Determination 2016/031

Regarding the issuing of a code compliance certificate in respect of thermal insulation to a hot water cylinder and hot water pipework to a house at 177 Keyes Road, Christchurch

Figure 1: Floor plan of the house showing location of the duct

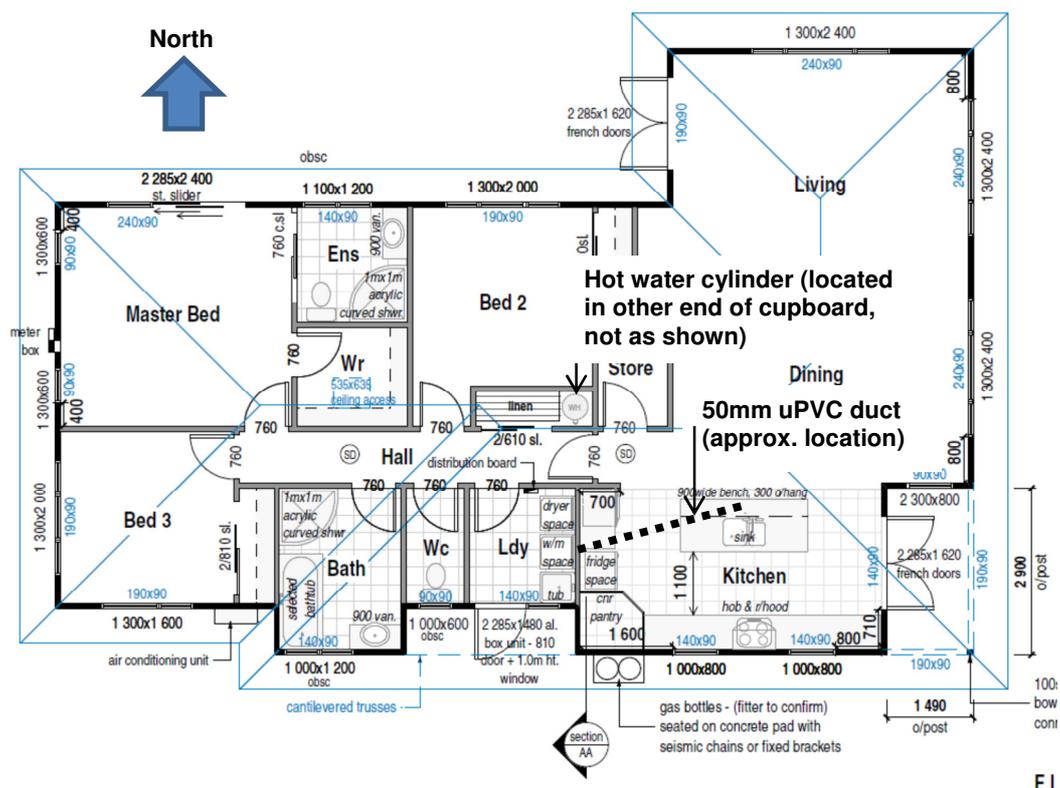
- 2.5 The kitchen sink and dishwasher are located in an island bench in the middle of the kitchen, with water and power run to the bench in a 50mm diameter uPVC duct, located in a slot cut into the polystyrene formers under the slab that runs west from the sink to the adjacent wall: the duct is approximately 3.0m long. The hot and cold water pipes and power cable run loose in the duct.

Figure 2: Schematic section showing 50mm duct located in floor slab

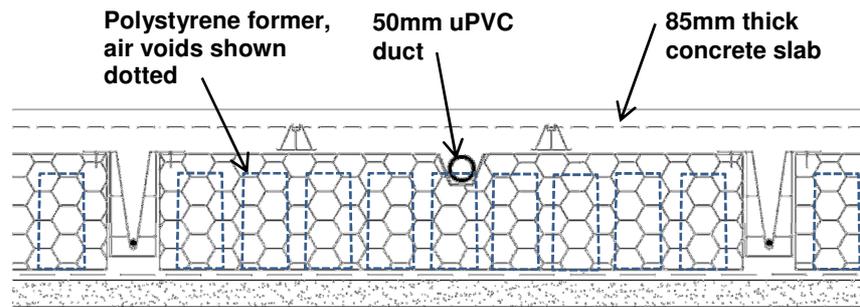
- 2.7 The formers are not solid polystyrene and have a 'honeycombed' underside with air voids formed in the underside of the former (refer Figure 2 above). The underside of the duct will be located over and/or be in contact with a mix of polystyrene and the air voids in the former. The minimum R-value of individual formers through their vertical dimension is approximately $1.2 \text{ m}^2 \cdot \text{C}/\text{W}$ (based on a minimum 50mm thickness of low density polystyrene taking account of the air voids).

- 6.5.9 The inspection records for the foundation show that the polystyrene formers were installed following the layout in the consent documents: this layout has the PVC duct running through two polystyrene formers in order to get from the sink to the adjoining wall as shown in Figure 1. The applicant says other pipework was installed in slots cut in the polystyrene formers and this is supported by site photographs taken during construction. It is therefore likely that the duct will have been installed in the bottom of such a slot as shown in Figure 2.

- 6.5.10 The requirement in NZS 4305 that hot water pipes not be embedded and in direct contact with concrete is to ensure that heat from the hot water is not lost to the surrounding mass. In this case the duct itself is partially embedded in concrete as it sits on the boundary between the concrete and the polystyrene formers, and I do not consider the hot water pipe itself is embedded in the manner contemplated in NZS 4305.
